<b>H2Teesside Planning Examination 2024-2025</b>	<b>Deadline 2 (D2), October 3<sup>rd</sup>, 2024</b>
--	--

<b>Author Details</b>	
Name	<b>Dr Andrew Boswell</b>
Position	<b>Independent Scientist &amp; Consultant</b>
NZT Registration	<b>20049368</b>
Organisation	<b>Climate Emergency Policy and Planning (CEPP)</b>

### **DEADLINE D2 SUBMISSION**

This written representation (WR) addresses whether Environmental Statement (ES) for the H2Teesside project realistically describes the Greenhouse Gas (GHG) emissions that the project would produce against the relevant latest science and knowledge of the natural gas supply market.

**Figure 1: IEEFA: Real World CO<sub>2</sub> Capture (2024)**

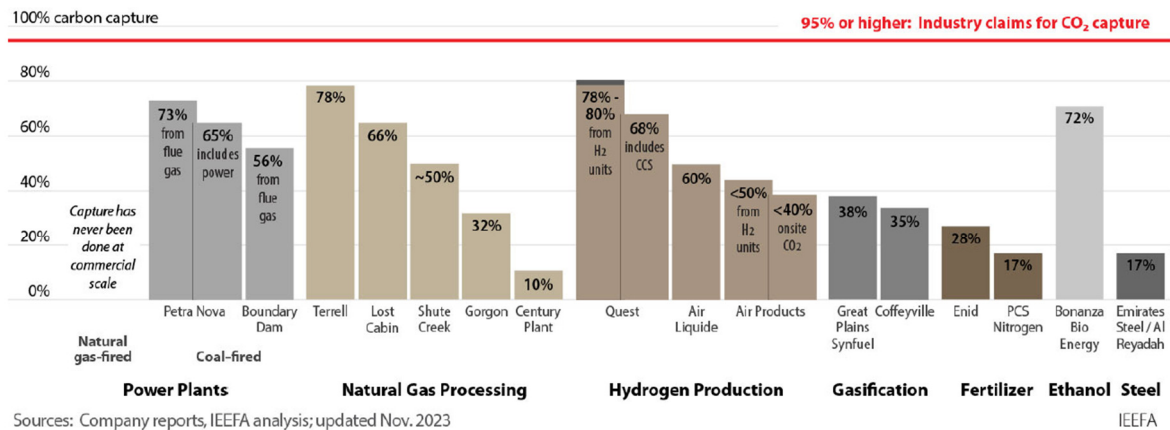
24 There are only three commercial-scale hydrogen production facilities in the world currently operating with CO<sub>2</sub> capture, as shown in the “Hydrogen Production” section of the slide above: Quest, Air Liquide and Air Products. In a related December 2023 paper (see Appendix D, page 18), IEEFA note that for hydrogen production, “*there are only three commercial-scale hydrogen production facilities in the world currently operating with CO<sub>2</sub> capture. All use SMR technology to produce hydrogen. None of these facilities has captured even 80% of the CO<sub>2</sub> they produce—and only one, Project Quest in Alberta, has captured 68% of its CO<sub>2</sub>. And it only appears to have achieved that level of performance if the emissions associated with the capture process are ignored. No CO<sub>2</sub> has been captured at any commercial-scale facility using ATR technology.*” (ATR is the technology proposed for H2Teesside).

25 The data above shows that the Quest plant has achieved 78% capture rate from its Steam Methane Reforming (SMR)<sup>8</sup> unit(s): the emissions from the associated furnace to power the SMR have not been captured. Quest’s website indicates that the average capture in 2023 was 75.2%. It is important to note that the type of flue gases from Quest and H2Teesside would

be very similar so the Quest plant may provide an existing reference for what would be possible in terms of capture rates at H2Teesside, and what would not be possible. The H2Teesside applicant has provided no evidence as to how it considers that it can achieve a 95% capture rate.

**Figure 2: Carbon intensity for different Natural Gas supplies**  
(reproduced from Carbon Tracker “Kind of Blue”, page 13, PDF page 16 –  
*the lighter shading shows the range of carbon intensities*)

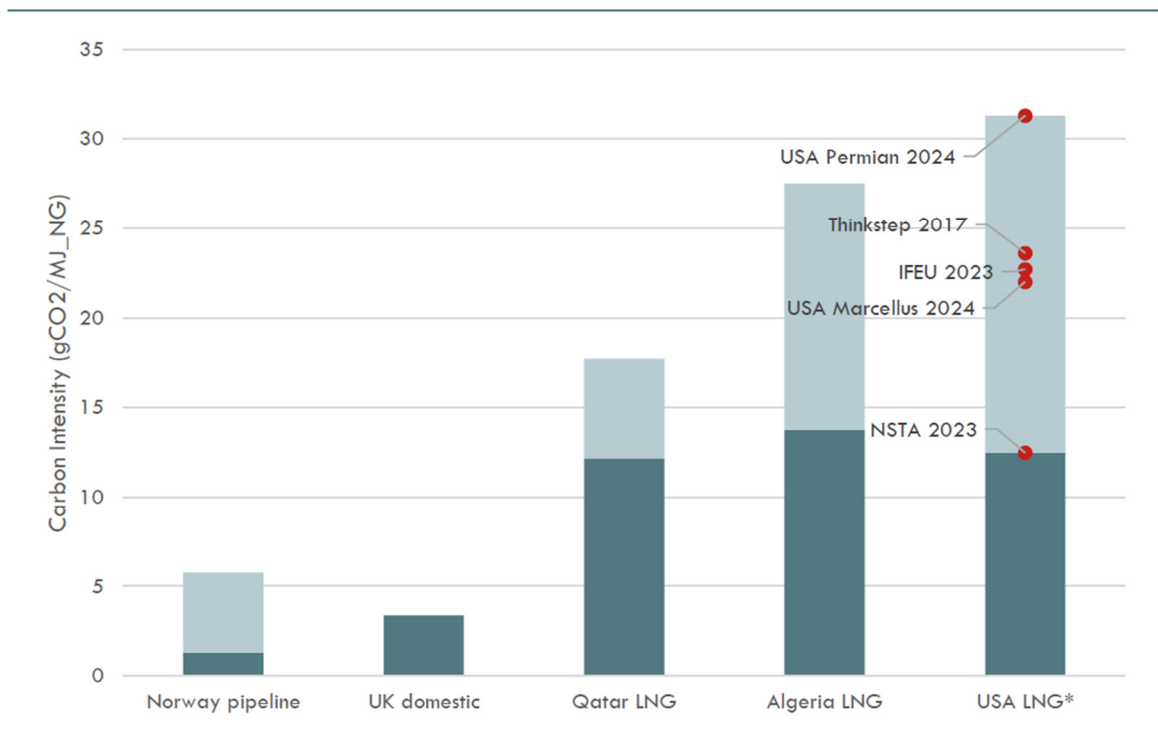
- (iv) LNG imports have a much greater upstream emission footprint than UK domestic or Norwegian pipeline sources, see below.

**Figure 3: IEA projections for methane reductions 2020-2030**  
(reproduced from IEA chart “Methane emissions from fossil fuels, historical and in the Net Zero Scenario, 2020-2030”)

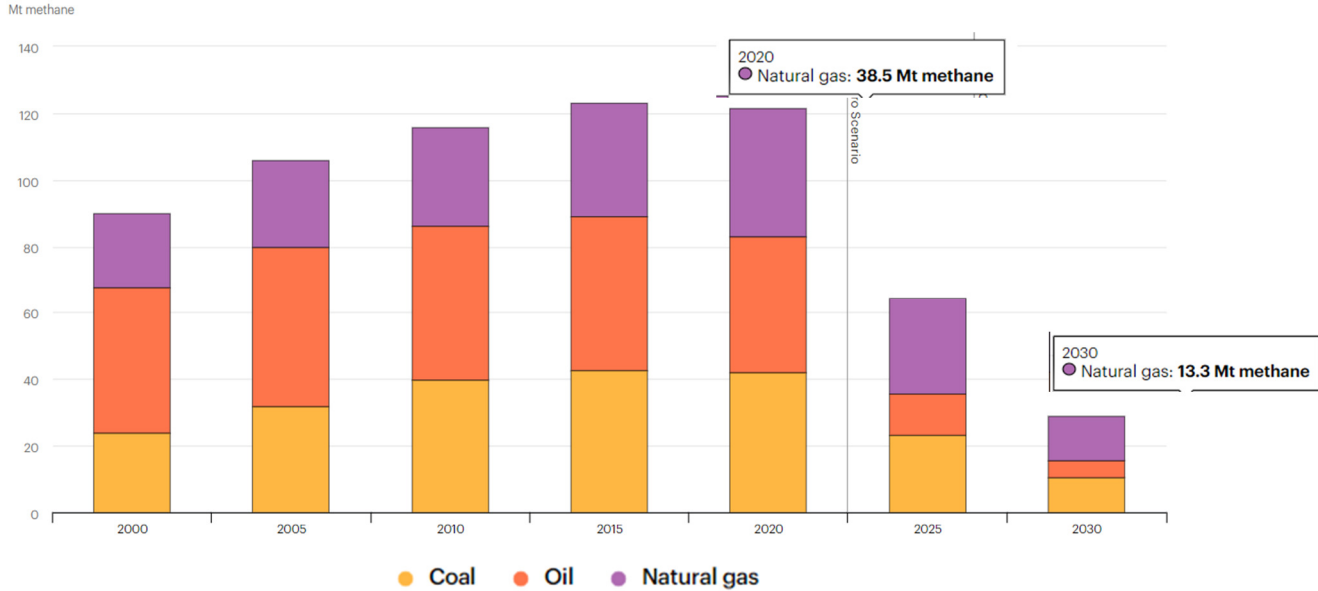
43 The IEA chart “Methane emissions from fossil fuels, historical and in the Net Zero Scenario, 2020-2030”, reproduced below, shows methane leakage reducing from global methane production from 38.5 MtCH<sub>4</sub> in 2020 to 13.3 MtCH<sub>4</sub> in 2030 to meet the IEA’s “Net Zero Emissions by 2050 Scenario” – a 66% reduction in ten years.

**Figure 5: Sensitivity Test on Natural Gas Supply (25-year Phase 2 Operational Emissions MtCO2e)**

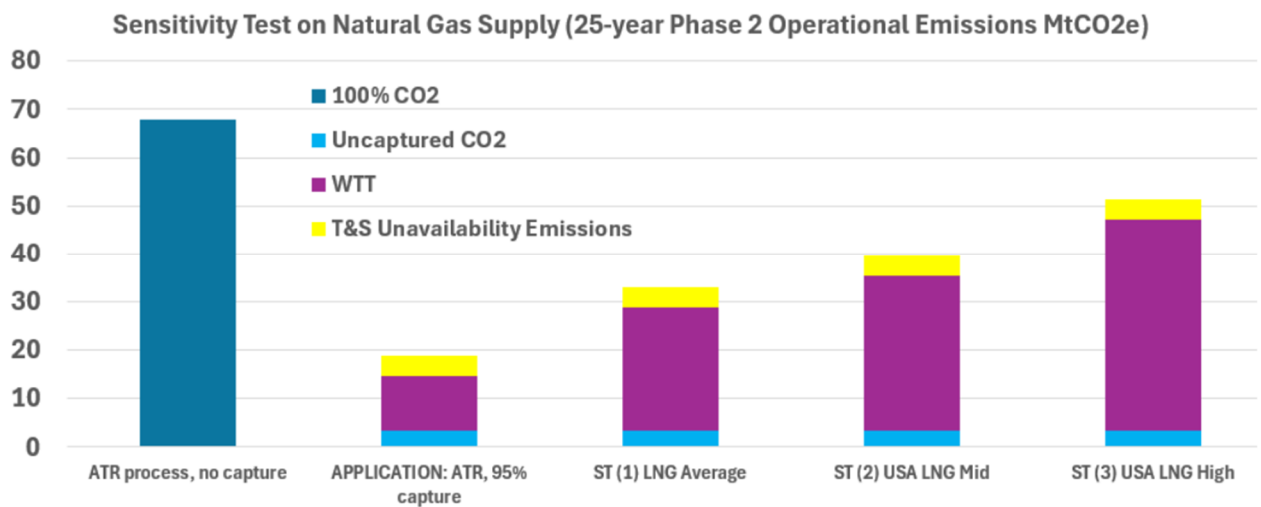
81 The figure above compares, over the 25 years Phase 2 operation, the unabated ATR process emissions (ie just unabated Scope 1 emissions of 67.98 MtCO2e), the 25-year operation emissions submitted by the applicant (19.13 MtCO2e), and for each sensitivity test: ST (1) : 33.29 MtCO2e; ST (2) : 39.84 MtCO2e; and ST (3) : 51.73 MtCO2e.

82 My operational emissions figures differ from those of Carbon Tracker, and this is for two reasons: I use the Phase 2 data where Carbon Tracker used the Phase 1 data, and I have included additional emission sources from the EIA which are not included in the LCHS standard<sup>39</sup>. This is correct for EIA purposes.

**Figure 6: Sensitivity Test on CCS rate  
(25-year Phase 2 Operational Emissions MtCO2e)**

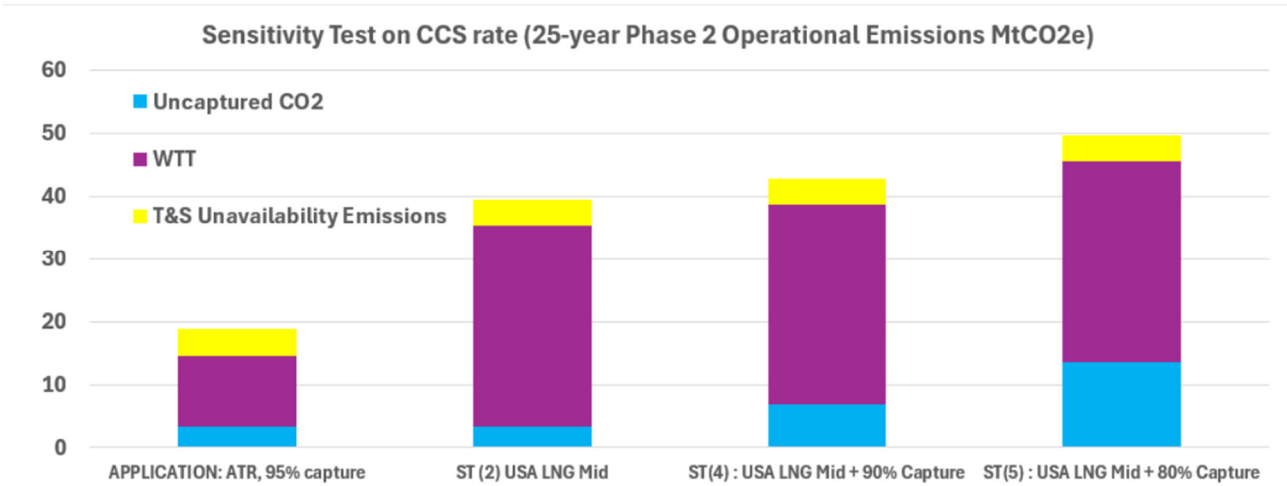
83 This sensitivity test investigates rates of carbon capture of less than 95%. I have based this sensitivity test on ST (2) USA LNG Mid, and then applied CCS rates of 90% and 80%. These values are reasonable given that IEEFA have shown that no commercial hydrogen CCS operation has reached over 78% capture rate to date (Appendix C, slide 12).

**Figure 7: Sensitivity Test on GWP  
(25-year Phase 2 Operational Emissions MtCO2e)**

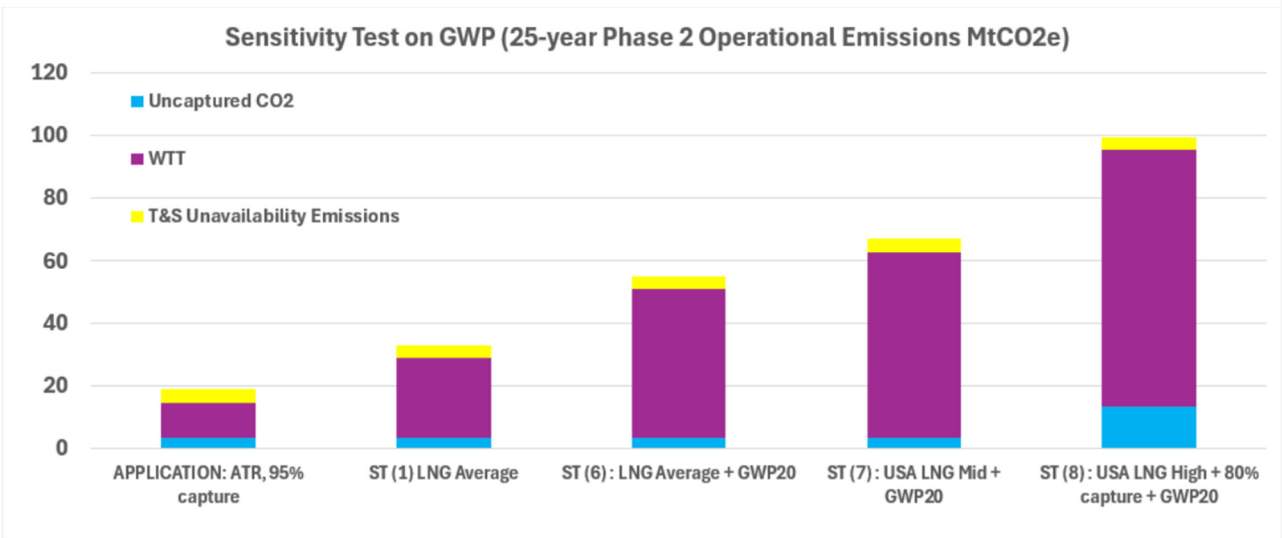
87 Having derived this “uplift factor”, the method for these sensitivity tests is to simply apply it to the upstream emissions in three selected scenarios. The results are shown below.

88 A reasonable worst-case scenario is obtained in ST (8) for LNG imported from the USA with high upstream emissions (“USA LNG High”) with 80% CCS capture and GWP20: in other words, it applies all three sensitivity test factors together. Note that ST (8) is considerably lower than IEEFA calculated using the DOE GREET modelling software (see Appendix D) as shown in the next section on LCHS compliance. So my analysis is far from being the worst-case analysis.

**Figure 7: Range of Carbon Intensities Reflecting 20-year GWPs and More Realistic Real-world Assumptions About Methane Emissions, CO<sub>2</sub> Capture Rates and Downstream Hydrogen Emissions**

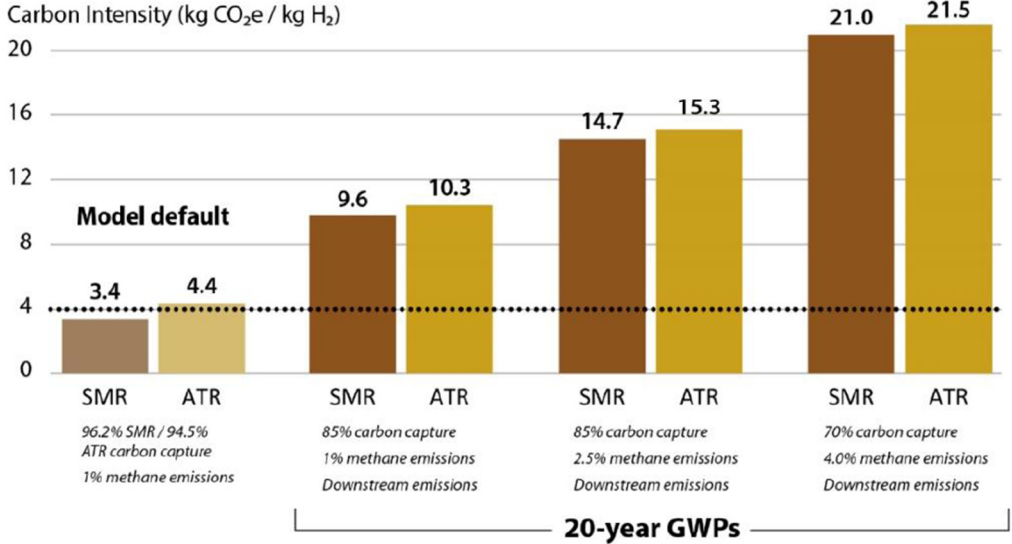
94 These sensitivity test should be contextualised by the IEEFA analysis where they ran the DOE GREET model using realistic assumptions including a GWP20 which models the real atmospheric impacts of methane over 20 years (see Appendix 4, page 26-27). Their results are shown below.
